PETITION FOR SPECIAL EXCEPTION

DESCRIPTION TO ACCOMPANY
SPECIAL EXCEPTION FOR
ROADSIDE FARMERS MARKET
MARYLAND ROUTE 30, UPPERCO, MARYLAND

PLAT TO ACCOMPANY
ZONING VARIANCE &
SPECIAL EXCEPTION FOR
FARMERS CO-OP ROADSIDE STAND
~~ROADSIDE FARMERS MARKET~~
HANOVER PIKE - UPPER CO. MARYLAND
4TH ELECTION DISTRICT BALTIMORE COUNTY, MD.
SCALE: 1" = 50' DATE: NOVEMBER 4 1985
REVISED 1-14-86 - ADDED ZONING VARIANCE IN TITLE ADDED MEANING IN ITEM N1
REVISED 2-7-86 - REV. LAYOUT TO ACCOMMODATE S.H.A. COMMENTS OF JAN. 9, 1986
HEARING CASE NO. 86-300 XA ITEM NO. 181

Re: Revised Comments
ZAC Meeting of 11-19-85
ITEM: #181.
Property Owner: Lippy Brothers, Inc.
Location: Centerline of Hanover Pike, Route 30, 1080' S. of Fringer Road
Existing Zoning: R.C. 2
Proposed Zoning: Variance to permit a crushed stone paving area in lieu of a durable and dustless surface (tar & chip) and a Special Exception for a farmers co-op roadside stand in an R.C. 2 zone
Acres: 8.7968
District: 4th

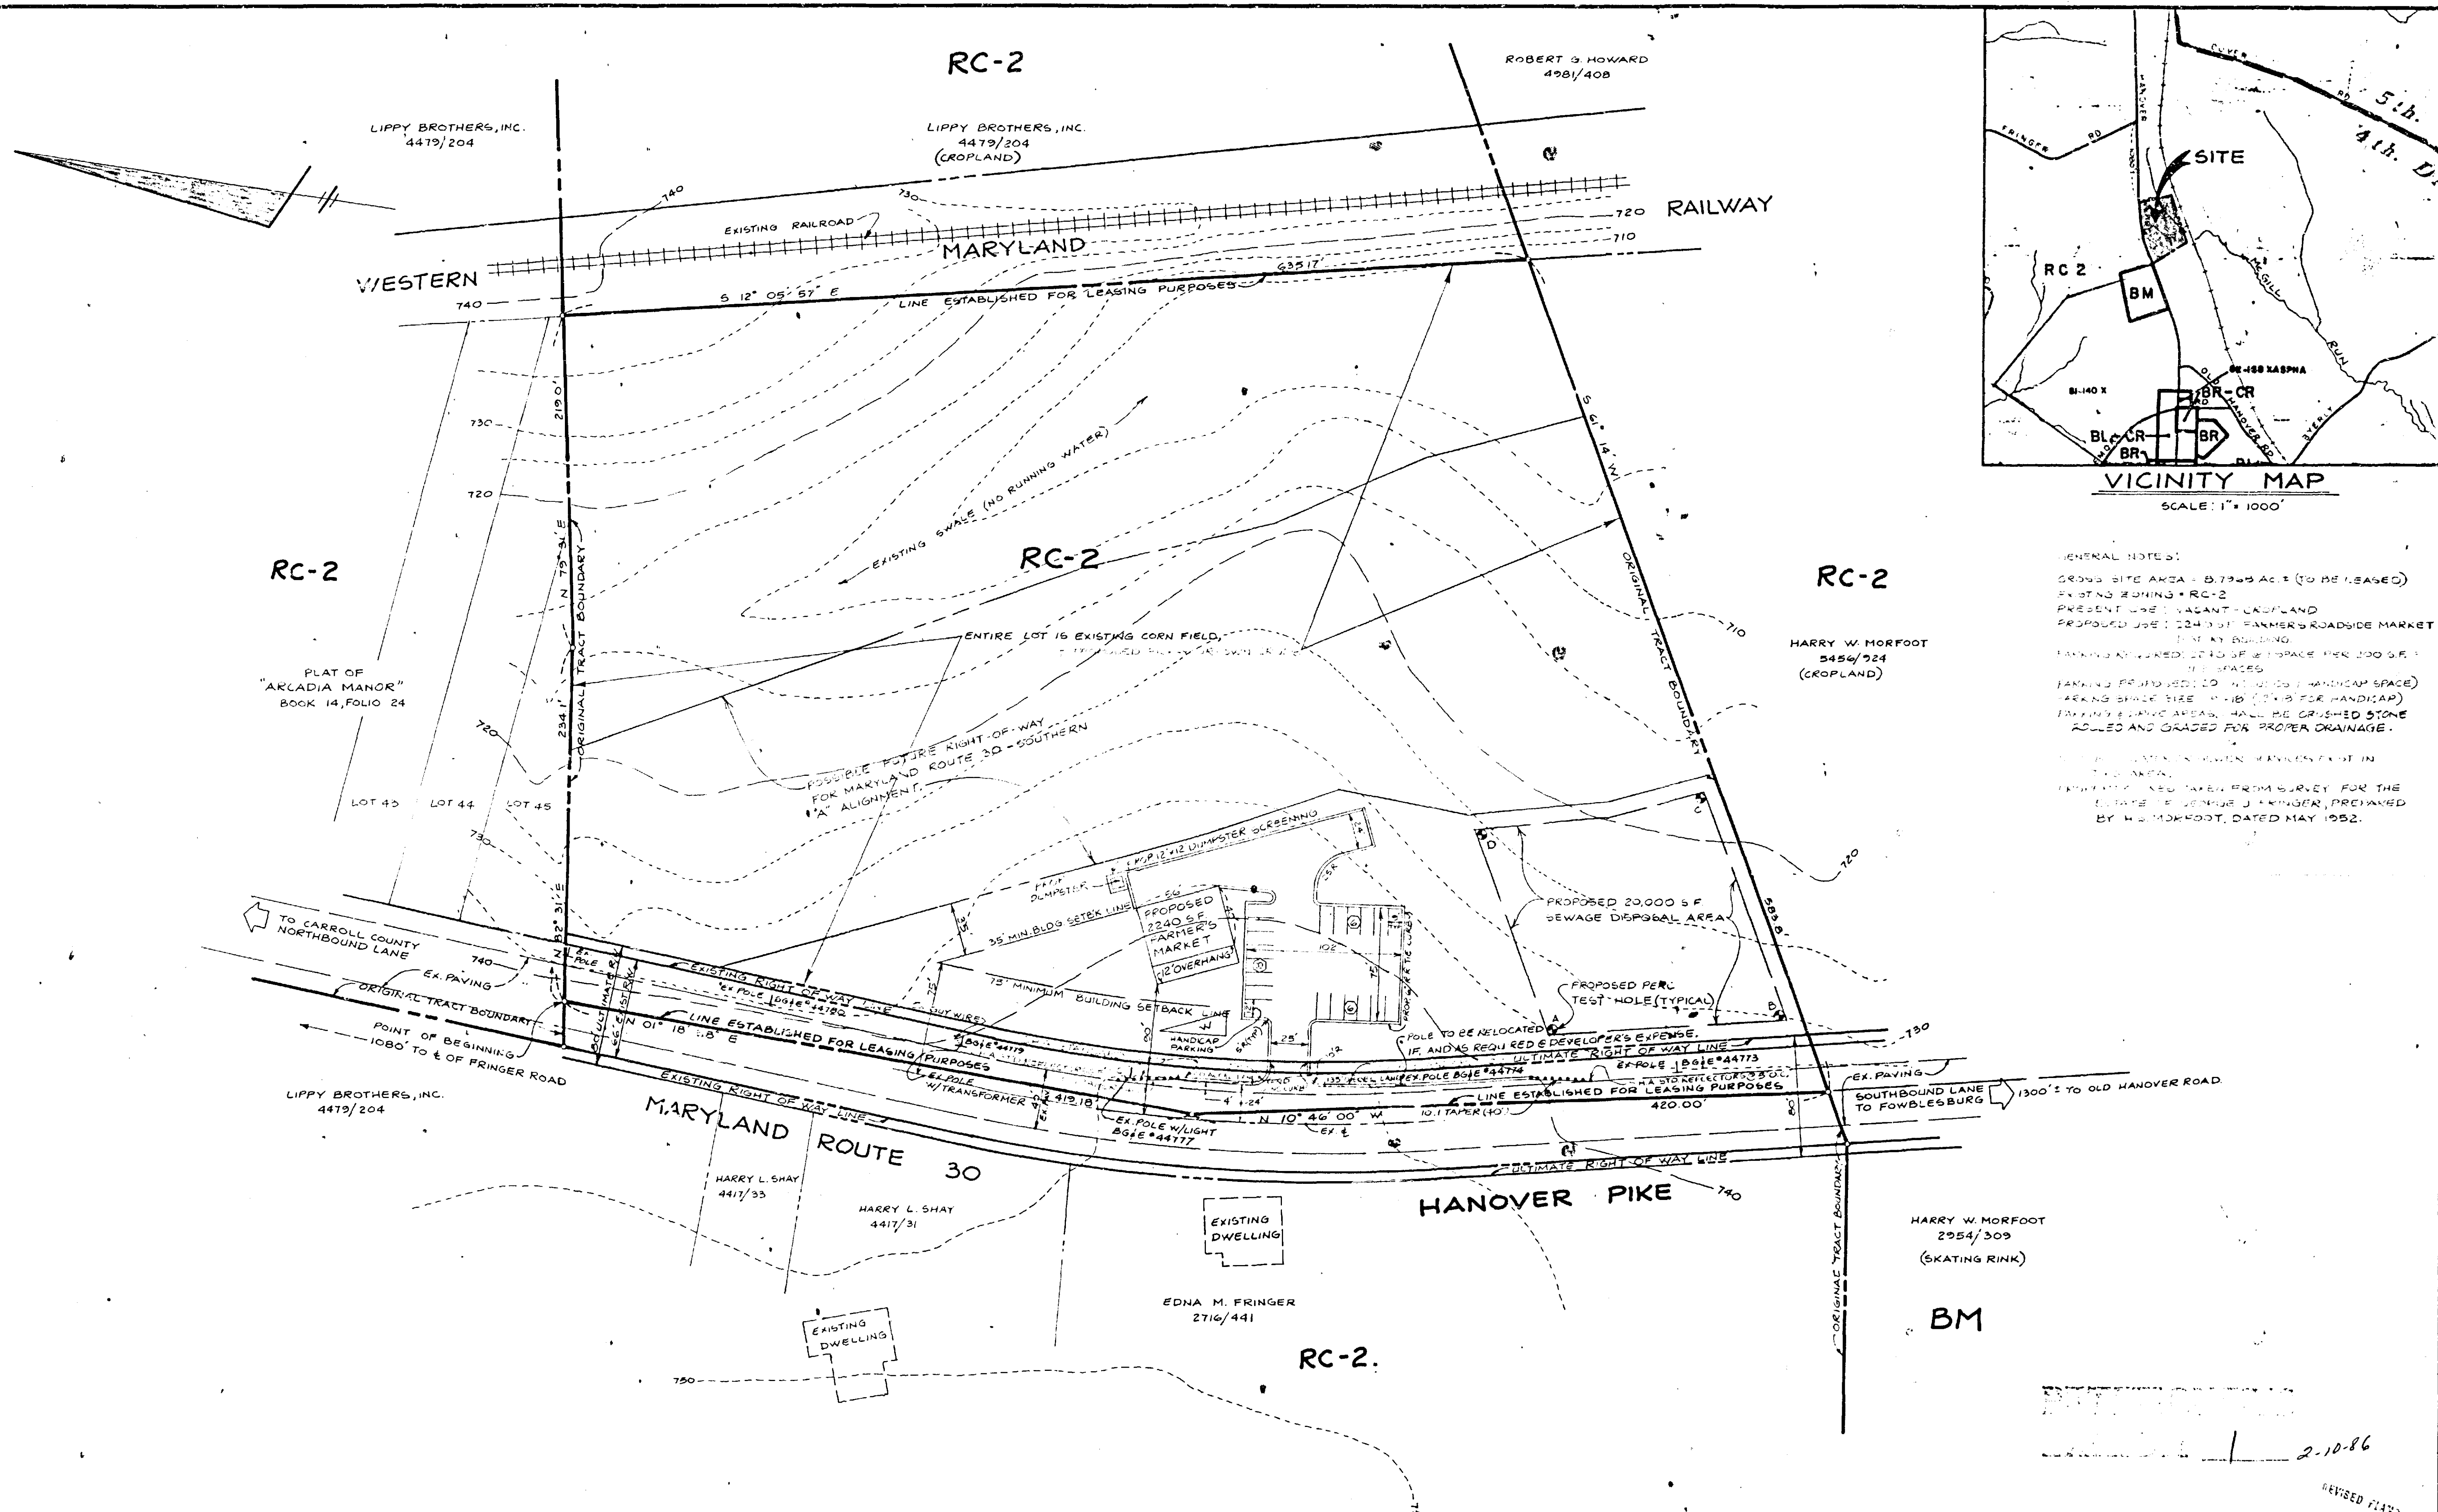
The State Highway Administration's Bureau of Engineering Access Permits will require revisions to the site plan.

The proposed deceleration lane south of the proposed entrance must be revised to show a 135' full width section with a 10:1 taper to meet the existing edge of roadway, and the proposed building relocated outside the proposed Right-of-Way.
